Work Order ID 141878

Item Name: Baggage Compartment Protector - Floor

DART SERVICE INSTRUCTION

TO AMEND INSTALLATION INSTRUCTIONS IIN-D407-781-2 REV. A OR LATER APPROVED REVISION
AND INSTRUCTIONS FOR CONTINUED AIRWORTHINESS ICA-D407-781 REV. 3 OR LATER REVISION

**FIGURE 1 - D3879-1 BAGGAGE COMPARTMENT WALL
PROTECTOR - ALTERNATE INSTALLATION**

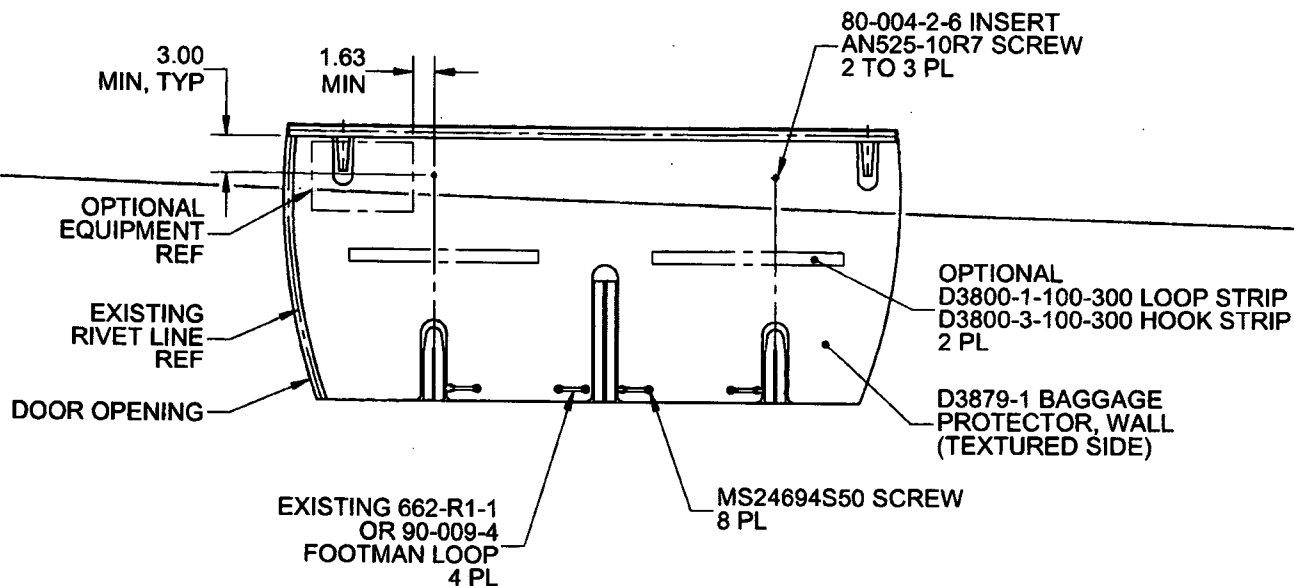
In some aircraft, the top portion of the D206-781-041 Baggage Compartment Wall Protector Kit cannot be installed as indicated in IIN-D407-781-2. The purpose of this DSI is to provide an alternate mounting method to fasten the top portion of the D206-781-041 Baggage Compartment Wall Protector Kit.

It is acceptable to replace qty(2) D3930-1 Clips with qty(2) 80-004-2-6 Inserts. Locate and mark location of the two attachment holes on the baggage compartment wall as shown in Figure 1 of this service instruction. Install 80-004-2-6 Inserts at the marked locations in accordance with Section 3-2-12 of BHT-206-SRM-1. It is acceptable to trim the wall protectors to accommodate optional equipment or transfer attachment holes to the wall protector and install the optional equipment on top of the wall protector with longer fasteners.

Amend the D206-781-041 Baggage Compartment Wall Protector Kit parts list as follows:

Qty -061	Qty -031	Qty -041	Part Number	Description
X			D206-781-061	BAGGAGE COMPARTMENT PROTECTOR KIT (FLOOR AND WALL)
1	X		D206-781-031	BAGGAGE COMPARTMENT FLOOR PROTECTOR KIT
1		X	D206-781-041	BAGGAGE COMPARTMENT WALL PROTECTOR KIT
		2	AN525-10R7	SCREW
		2	80-004-2-6	INSERT
